HISTORIC AND DESIGN REVIEW COMMISSION

HDRC CASE NO: 2021-295
ADDRESS: 914 N PINE ST
LEGAL DESCRIPTION: NCB 1653 BLK A LOT 5
ZONING: R-5, H
CITY COUNCIL DIST.: 2
DISTRICT: Dignowity Hill Historic District
APPLICANT: David Ericsson/PINE 14 LLC
OWNER: David Ericsson/PINE 14 LLC
TYPE OF WORK: Amendment to a previous approval for new construction of two rear accessory structures
APPLICATION RECEIVED: June 18, 2021
60-DAY REVIEW: Not applicable due to City Council Emergency Orders
CASE MANAGER: Edward Hall
REQUEST:

914 N PINE STREET DESIGN REVISION

FOOTPRINT 1: UNCHANGED
FOOTPRINT 2: REDUCED

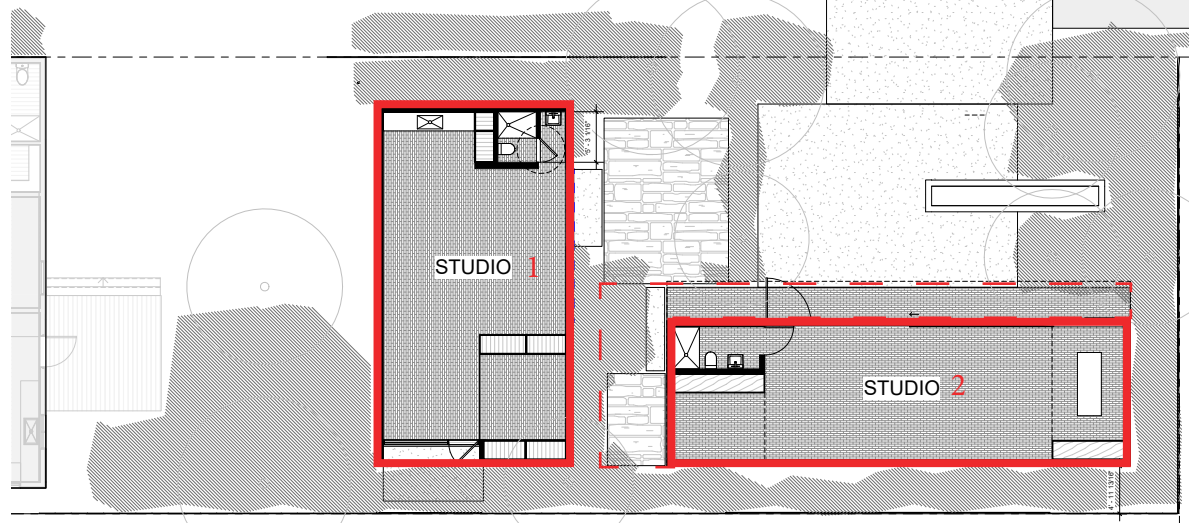
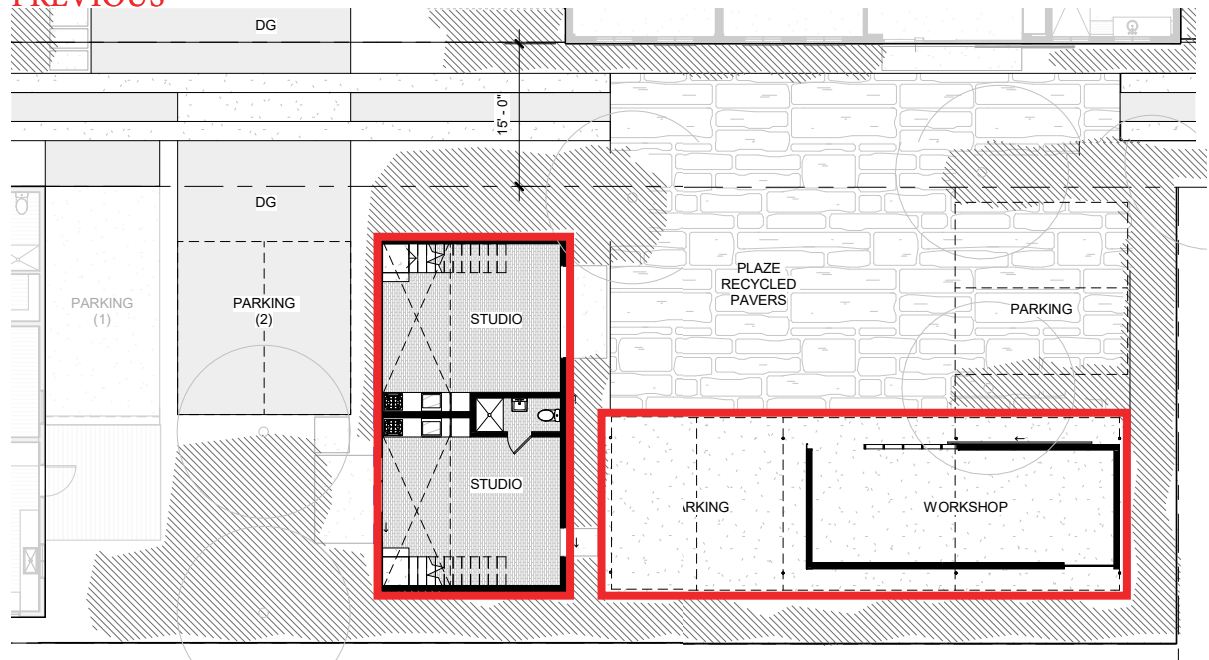
OVERALL FOOTPRINT REDUCED

In order to move forward with structures at 914, parking will be provided in existing parking lot at 918. The previously approved duplex masonry structure was value engineered into a single unit structure, with roof-line lowered, losing mezzanine level. To gain back lost unit, previously approved carport and workshop structure was shortened by 6', and workshop volume was modified to house additional studio.

STUDIO ELEVATIONS NORTH

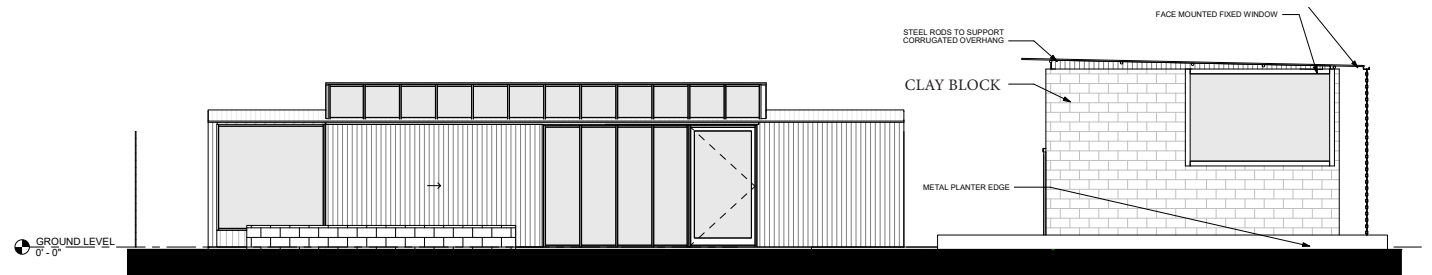
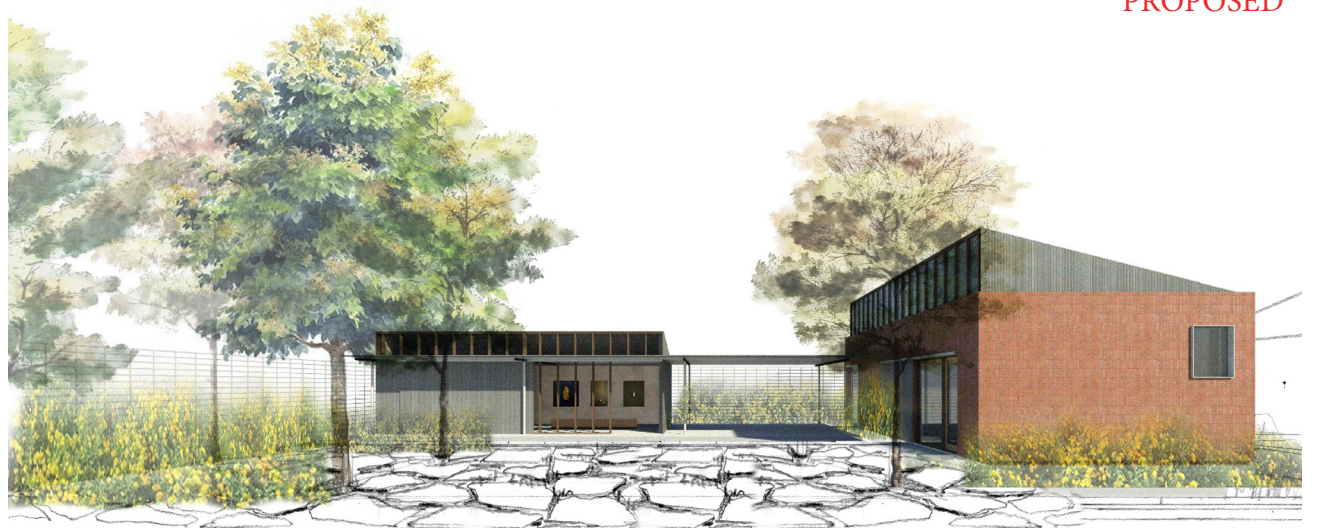
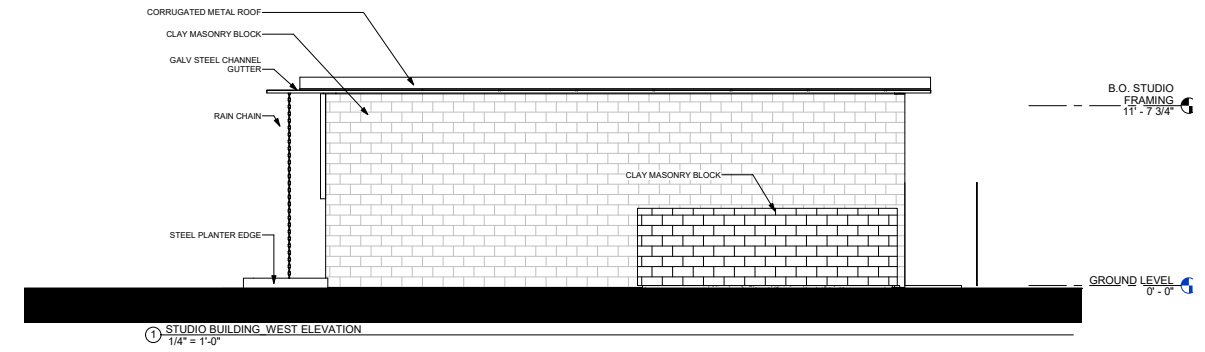
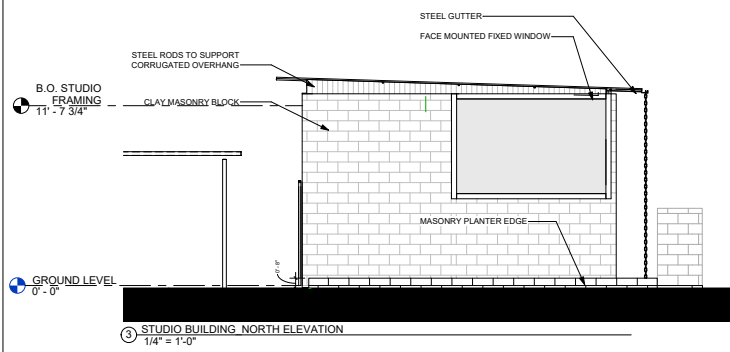
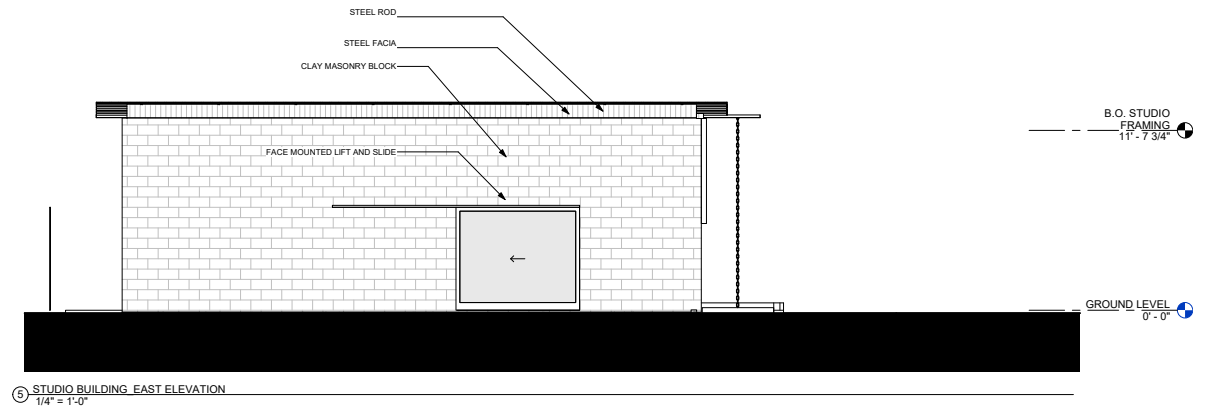
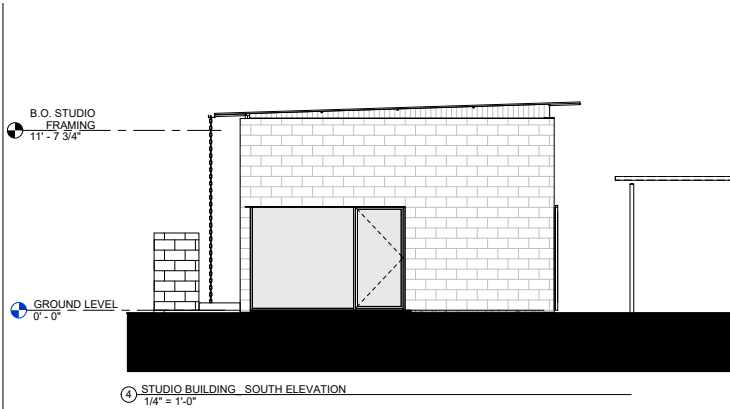
Approved duplex masonry structure roof-line lowered, losing mezzanine level, going to a one unit studio structure. Carport and workshop structure shortened by 6', housing additional studio that was lost in the revised masonry structure.

STUDIO 1 ELEVATIONS

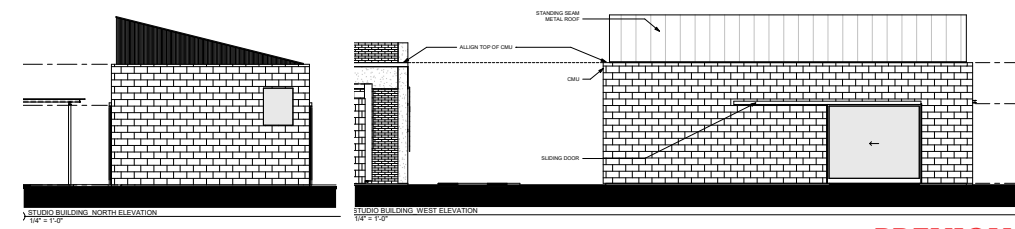
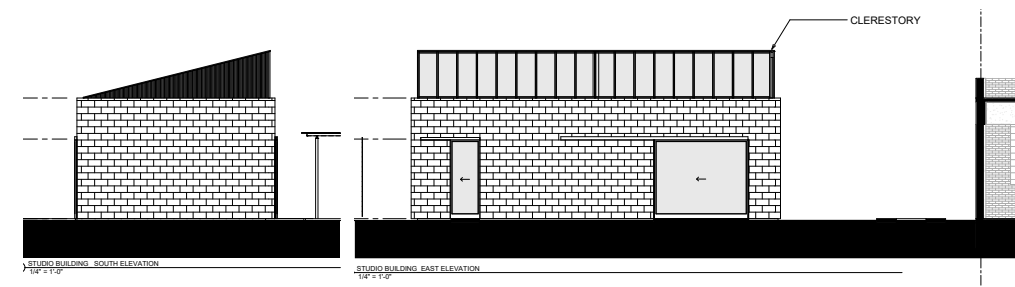
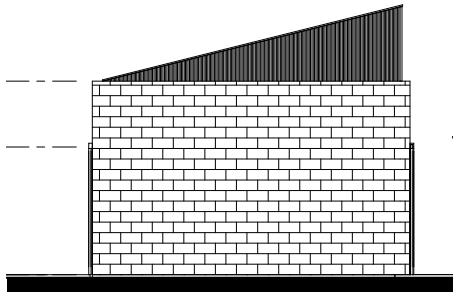
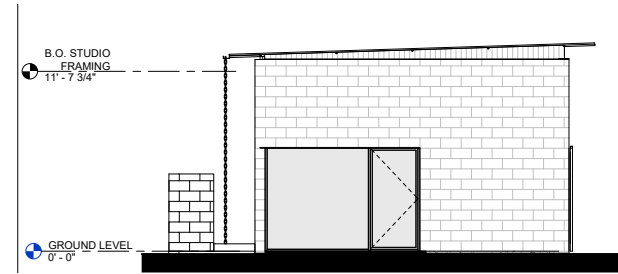
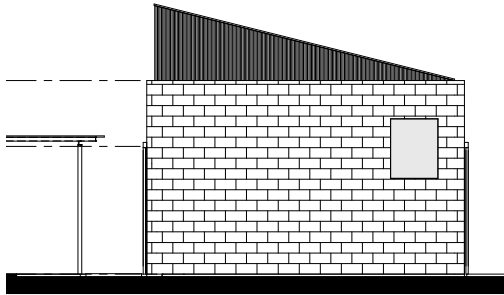
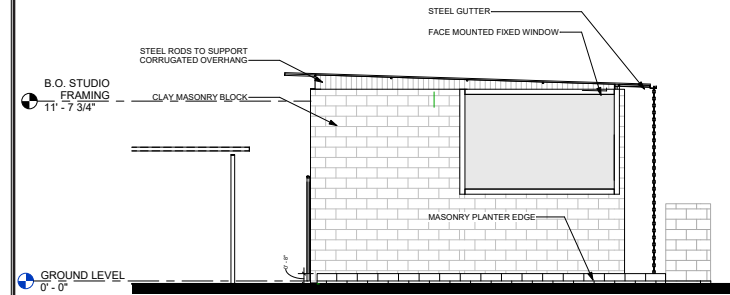
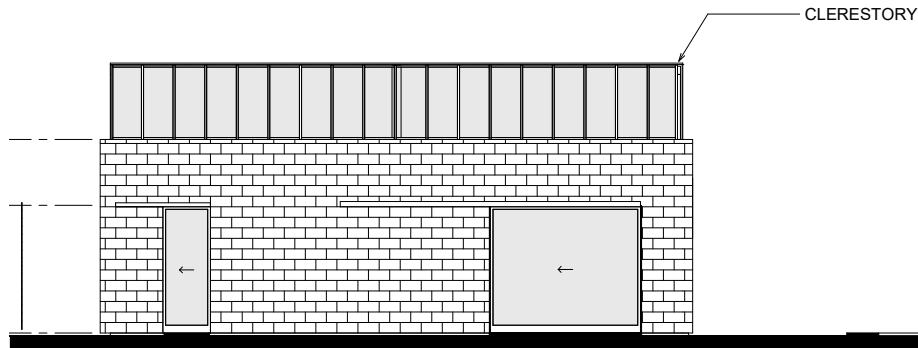
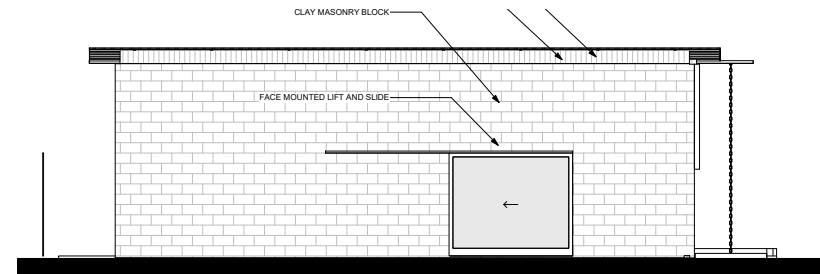
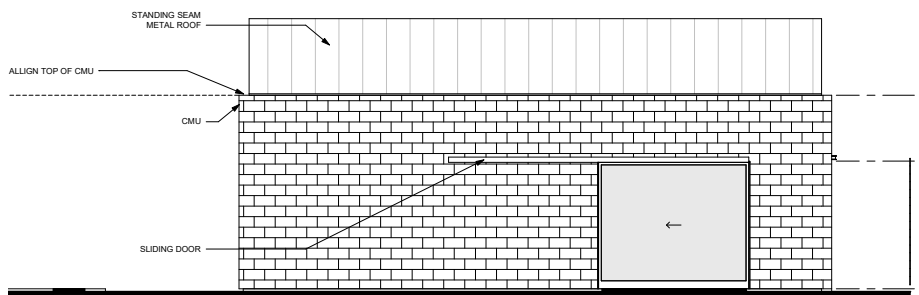
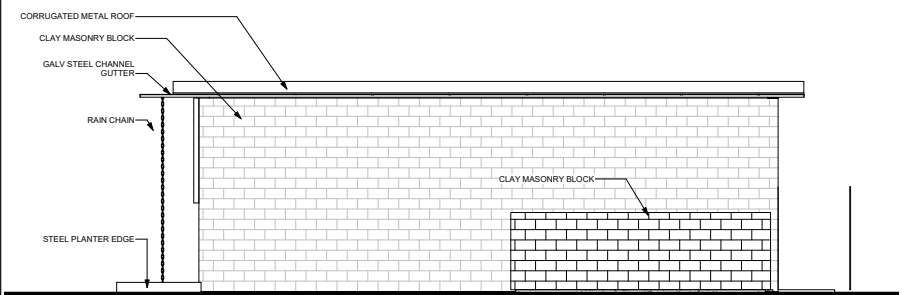
ROOF PITCH LOWERED/LOSS OF CLERESTORY

NORTH WINDOW ENLARGED

WEST WINDOW MOVED TO SOUTH FACADE, AND RECESSED

Approved duplex masonry structure roof-line lowered, losing mezzanine level, going to a one unit studio structure. North window made larger, with west window being moved to south elevation for better daylighting.

STUDIO 2 ELEVATIONS SOUTH/EAST/WEST

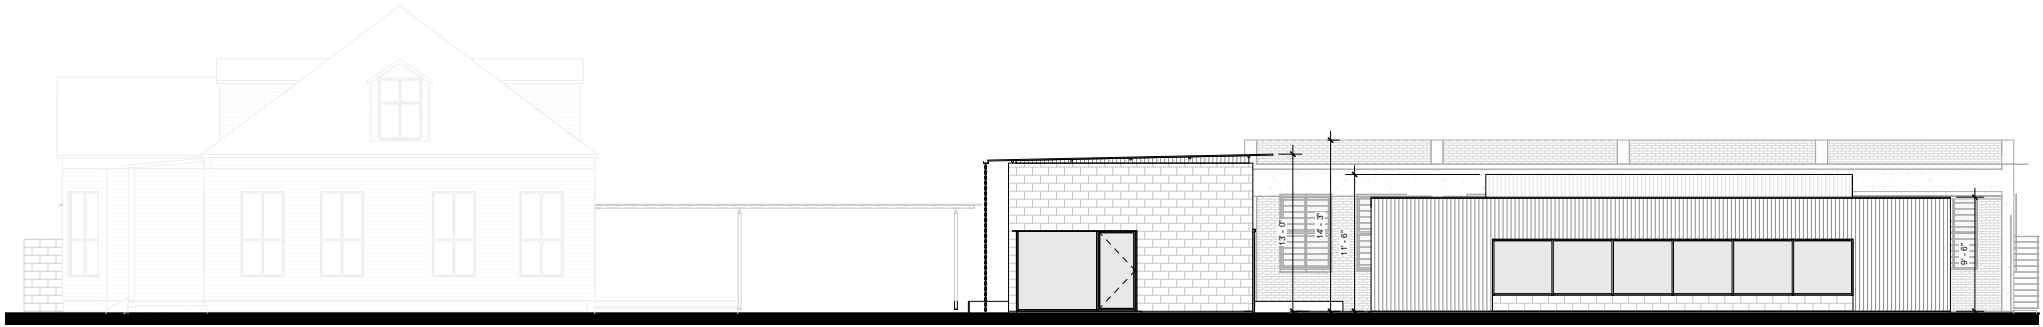
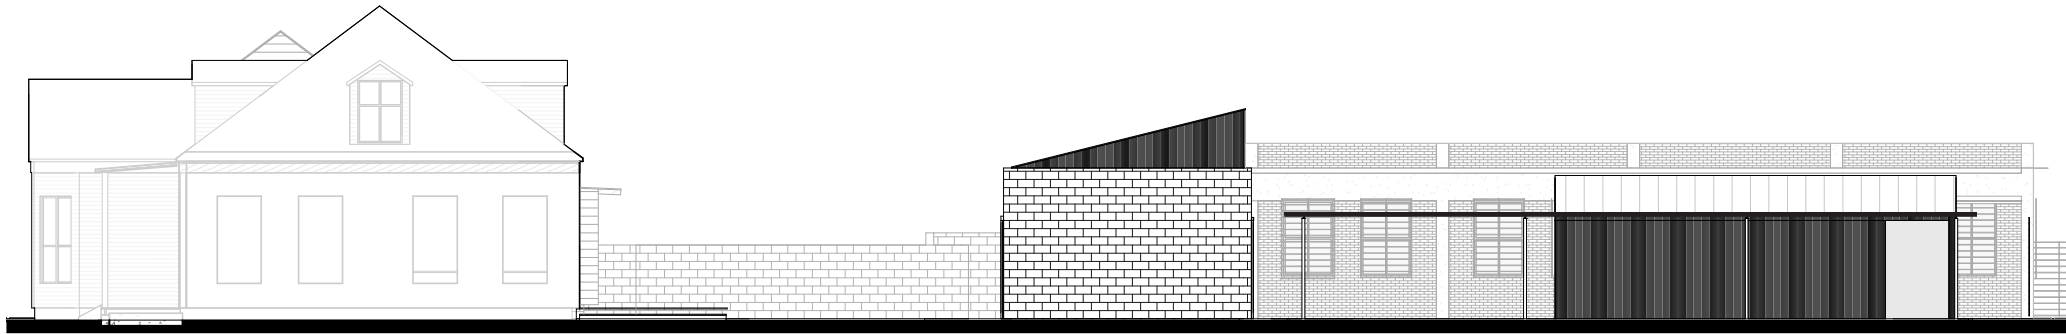
Previously approved workshop structure now studio 2, simple east/west elevations were not previously elevated in approved scheme, but clerestory was maintained, along with roof overhangs of previously approved structure.
